TRAFFIC IMPACT AND PARKING STUDY – REVISED

2103-2119 Primate Road, 1351 & 1357 Wealthy Place,
2116 & 2112 Dixie Road

Project No. 2017-0294

**Re: Traffic Impact and Parking Study – Comments / Response Letter
2103-2119 Primate Road, 1351 & 1357 Wealthy Place, 2116 & 2112 Dixie Road
City of Mississauga
Application No. Draft Plan of Subdivision (21T-M 18 2)**

WEALTHY PLACE CUL-DE-SAC
PROPOSED RESIDENTIAL DEVELOPMENT
CITY OF MISSISSAUGA
REGION OF PEEL

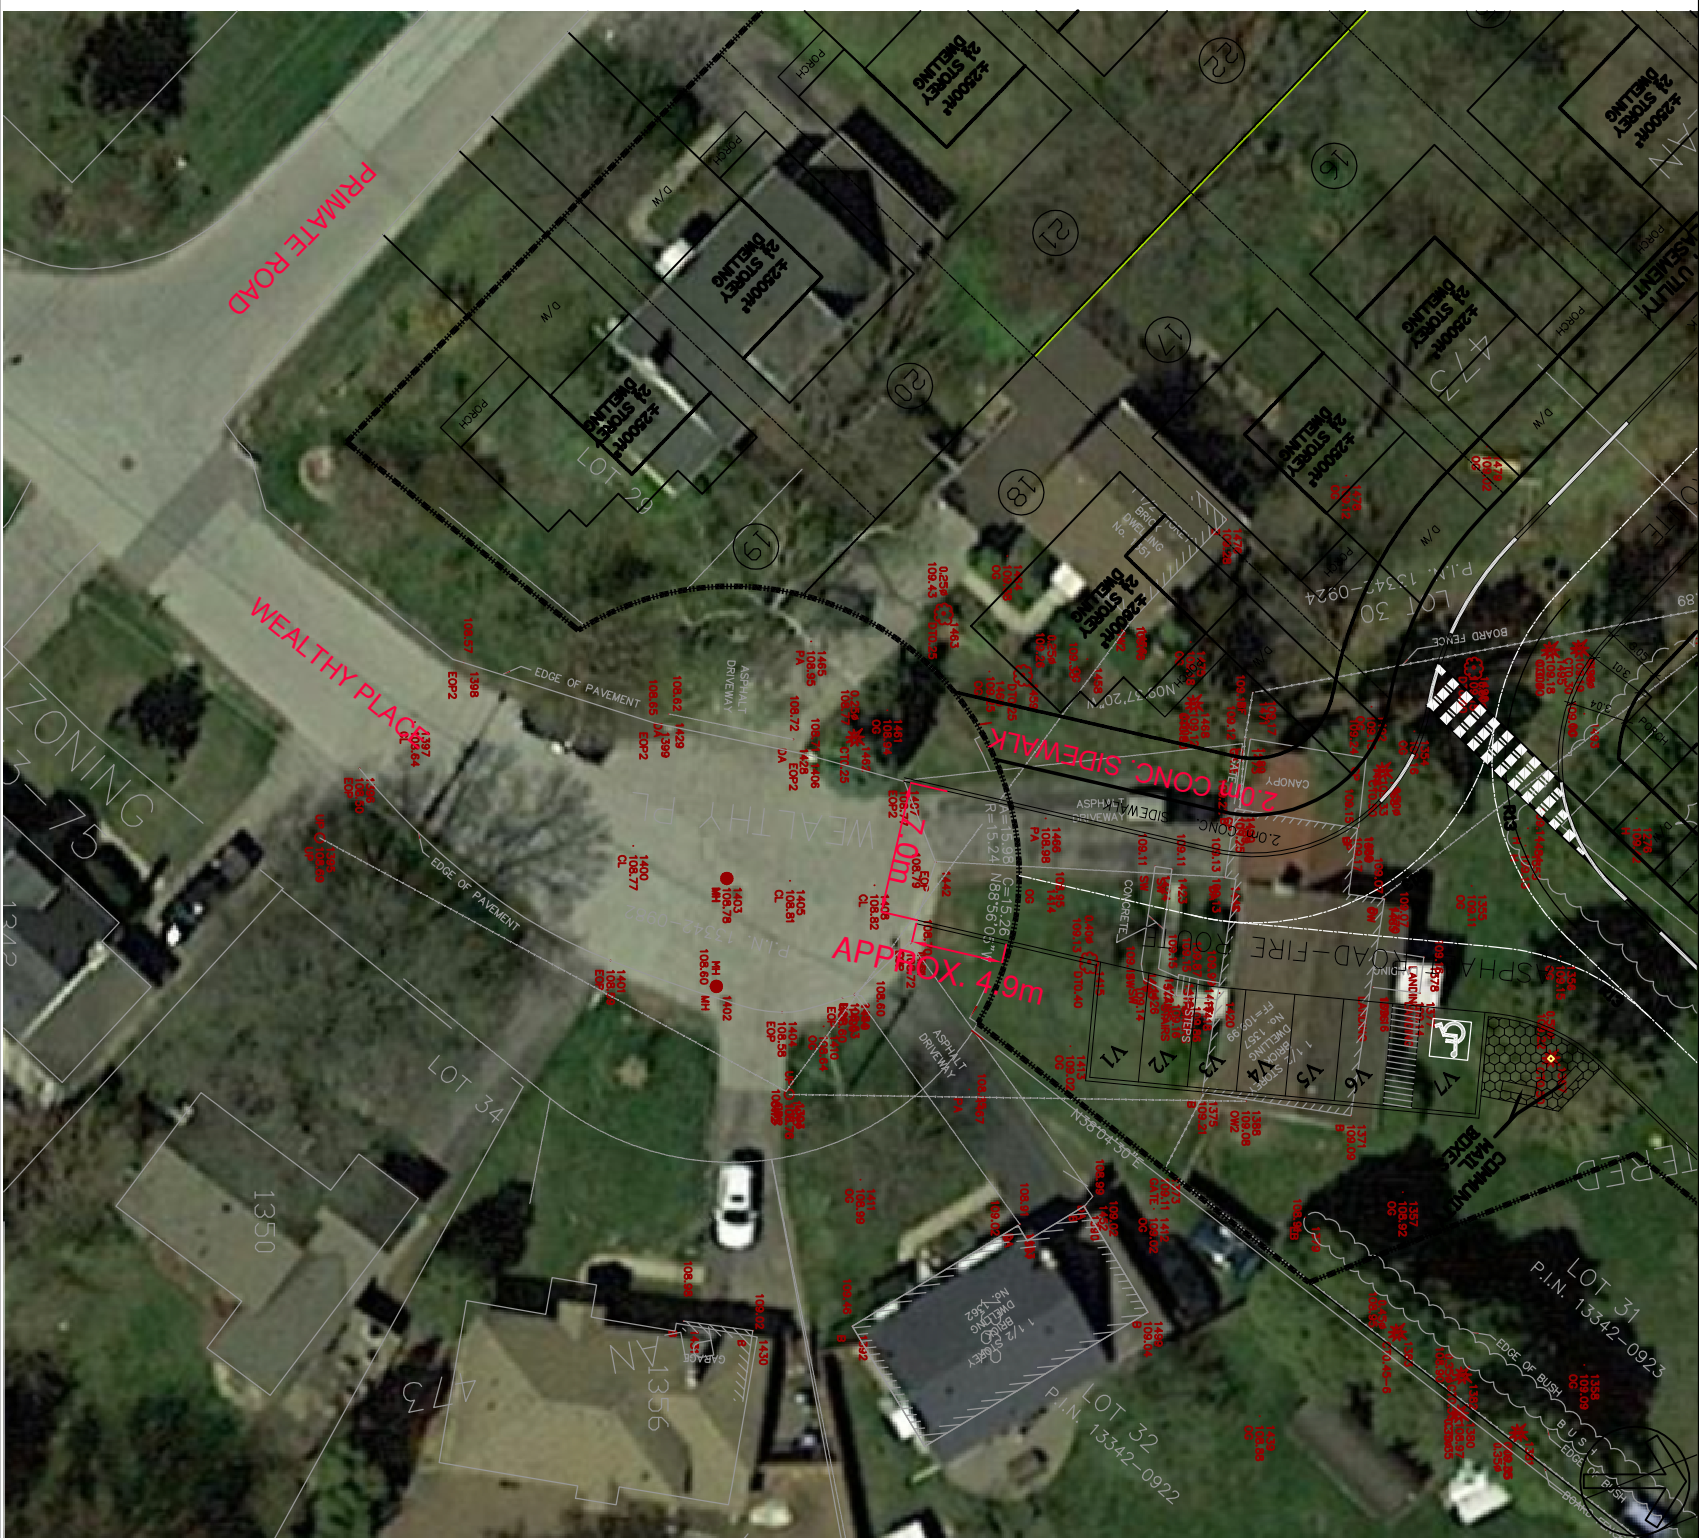
| <i>Dimension the access width at the edge of pavement.</i> | Dimension provided on Figure 6-1 |
| <i>Indicate the municipal curb and sidewalk continuous through the driveway.</i> | Dimension provided on Figure 6-1 |
| <i>Provide a minimum 1.5m setback between the edge of the driveway mouth at the street line to the projected property line.</i> | Dimension provided on Figure 6-1 |
